# City of Vallejo

## Architectural Heritage and Landmarks Commission

**SUBJECT:** Agenda Item 13a  
Continuation of review of Certificate of Appropriateness #07-0045  
(Alden Park)

**Mare Island  
Alden Park  
Pathway Repair and Maintenance  
Application for  
Certificate of Appropriateness  
Date: 1-17-08**

**PLAN VIEW - ALDEN PJ**  
SCALE 1" = 50' HORIZ.

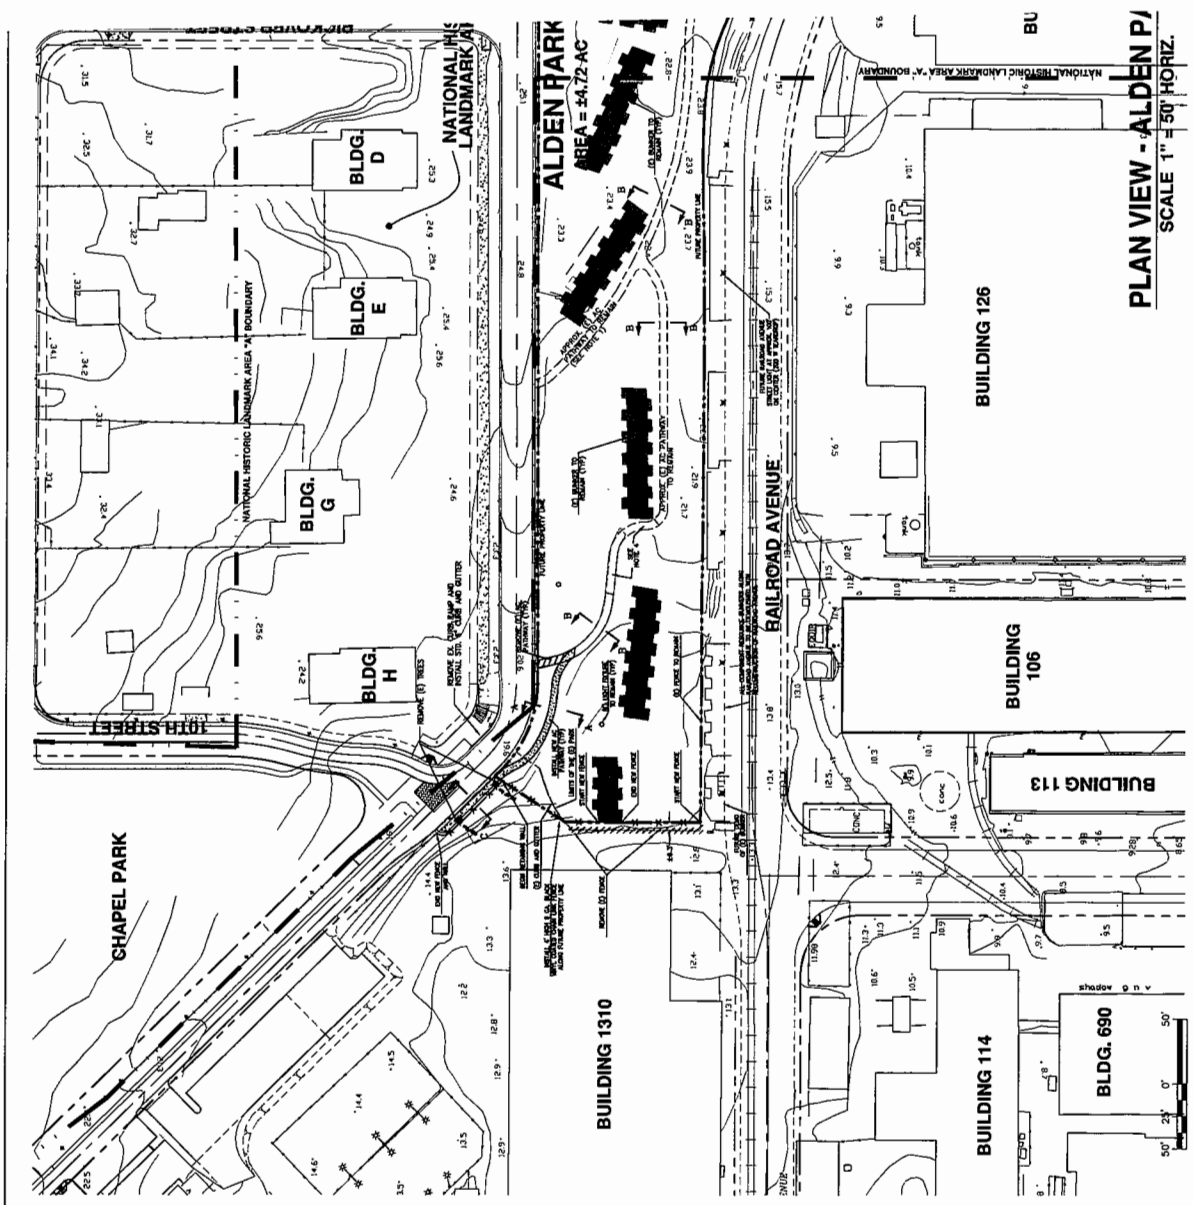
- Revised surface treatment of the existing pathways. The paths were previously proposed to be widened, with an associated possible material change, but the revised proposal shows only surface maintenance, including repair and/or replacement using asphalt (“asphaltic concrete” or “A.C.”) that matches the existing pathway material, and a consistent pathway width of five feet. The previous proposal for the path was intended to meet or closely represent current standards for multi-use paths; however, the revised proposal is to provide a smooth pathway surface for use by a variety of pedestrian and bicycle traffic, but the width of the path would not meet typical multi-use path criteria. This revised portion of the proposal would meet the intent and letter of any definitions of “maintenance.”

- The extension of the main pathway to the southwest corner of the park, at a reduced width than previously proposed. The route of the path does not impact any features within the proposed or current park boundaries—it passes through an existing lawn area and then passes out of the park into the area of Building 1310. The path extension is a minor change that is required per the Public Works Department in order to provide a safe crossing near Chapel Park and is not part of the NHL Area. Consistent with the previous proposal, the revised plan includes removal of an existing gutter and ramp, and construction of a curb on the west side of Walnut Avenue near the corner of 10<sup>th</sup> Street to discourage crossing at this location.

- Clarifications to the drawings that indicate that no light fixtures are proposed for removal from within the park area, and no bunkers or trellises are shown to be demolished as part of this project. Small sections of the fence in the northeast corner of the park will be removed to accommodate adequate path access. Removal of several bunkers outside of the park boundaries and installation of new light fixtures along Railroad Avenue will be addressed as part of a separate project.

- Future boundary lines for the park that have been changed from the previous proposal. As shown in this proposal, the future property lines/right-of-way lines follow the existing fenceline to the east, follow the sidewalk edge to the north, follow the curbs along Walnut Avenue to the west, and are inset approximately 6' from the existing fenceline at the southern end. To accommodate vehicle and truck access required for reuse of the Building 1310 "Triangle" area, the previous proposal included a boundary line at the southern end that would conflict with an existing bunker and trellis. However, in order to retain the bunker and trellis, the applicant has indicated their willingness to work with a narrower driveway at this location.

- Relocated fencelines for this proposal. As noted above, the previous plan showed a new southern fenceline that conflicted with an existing bunker and trellis; the proposed new fenceline is closer to the existing location than previously proposed and would be approximately 6' north of the existing fenceline. The proposed fence material and height (four-foot, chainlink and black-coated) is in keeping with the Standards and Guidelines. The relocation and replacement of the fence would fall within the definition of maintenance, as the replacement is with similar materials and provides the same purpose as the previous southern fence.

1. A designated AHLC member or members shall review the field staking for the pathways prior to construction.
2. The applicant shall ensure that a licensed arborist is on-site to oversee pruning of listed trees to ensure that trimming is done within City of Vallejo standards.
3. The site grading detail, wall elevations and the selection of the retaining wall material shall be submitted to the Secretary of the AHLC and Public Works Department for review and approval prior to submittal of a grading permit.
4. Any new construction or improvements that border the park, including along Walnut Avenue, 8<sup>th</sup> Street, Railroad Avenue, and within the Building 1310 "Triangle" area shall be subject to AHLC review.

ALDEN PARK PATHWAY PLAN  
OCTOBER 26, 2007

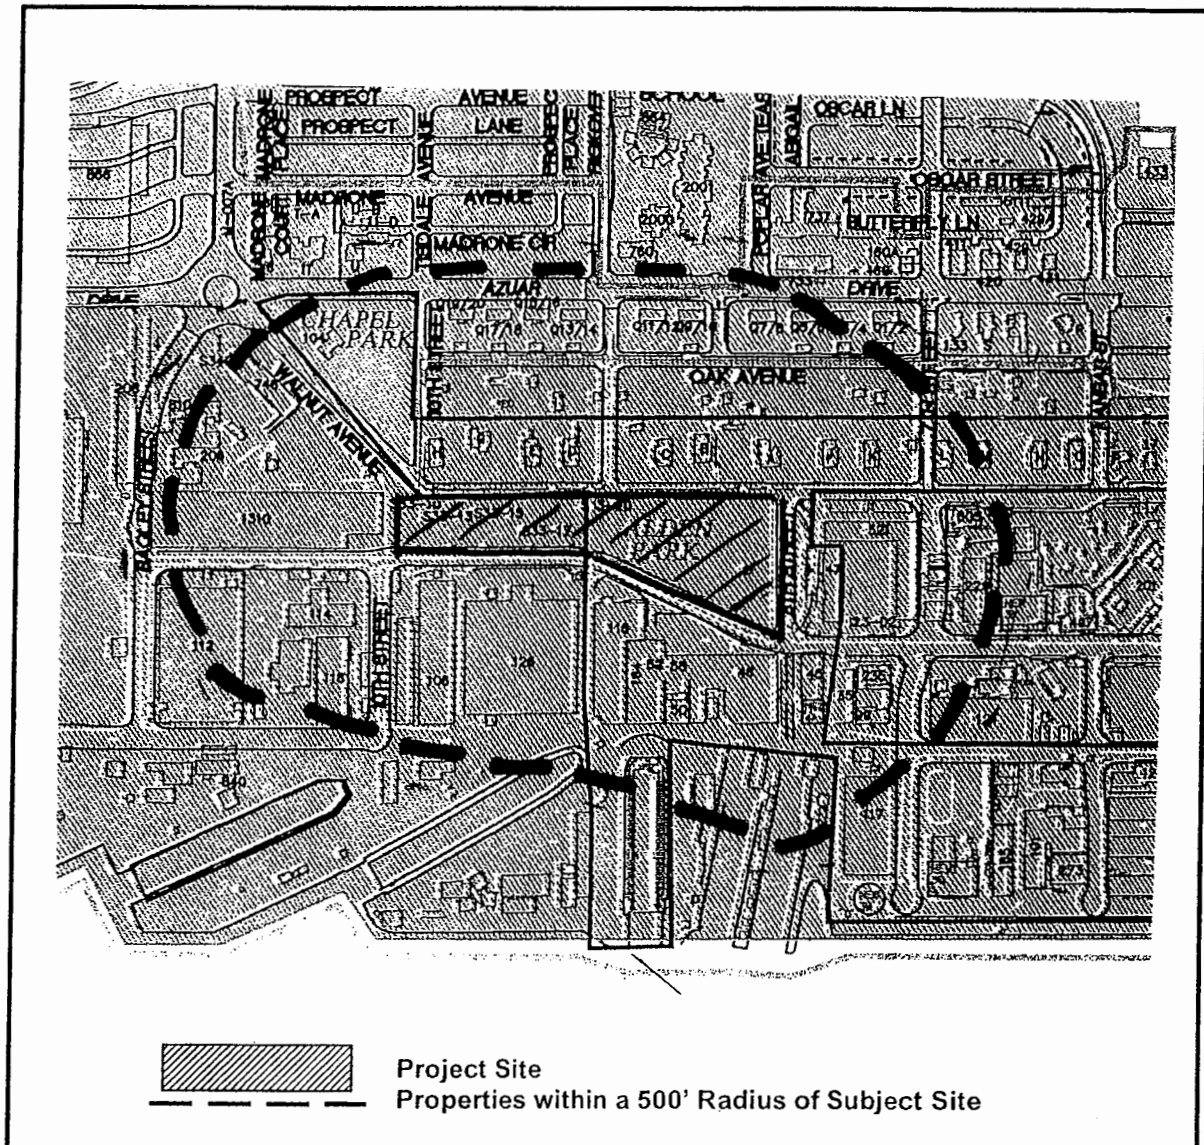
- The project description does not outline materials. In discussion with Staff the question of use of asphalt versus decomposed granite was discussed.
- Drawings indicate details for Keystone retaining walls, which are inappropriate.

- The description of the project fails to cite the construction of new retaining walls, the removal of trees (indicated on the plan), the relocation of an existing trellis, and in addition the removal of part of another bunker.
- The staff report fails to discuss the removal of two trees, which are obviously part of a road widening project – as is the removal of the bunkers. Anotherwards, you are being asked to approve work tacitly related to another project not before you.

It is not clear from the drawing that only one portion of the path, from the northeast corner of the park, to the southwest corner of the path will be widened. It is recommended that the plans be clarified to show that the path from the flagpole to the main path, and the two segments of paths from Walnut Avenue to the main path may be narrower than the multi-purpose path. Although the path originally connected to the officer's quarters at the southwest end of the park, due to potential vehicular conflict, the proposal is to realign the path to connect at the crosswalk located on the corner of 10th and Walnut to provide a safe pedestrian crossing.

2. Disallow the use of Keystone material, and require redesign of the materials and identification of all proposed retaining walls to be brought back for approval by the AHLC for review and approval.

1. A designated AHLC member or members shall review the field staking for the pathways prior to construction.
2. The plans shall be clarified to show that the path from the flagpole to the main path and the two segments of paths from Walnut Avenue to the main path be narrower than the main, approximately diagonal multi-purpose path.
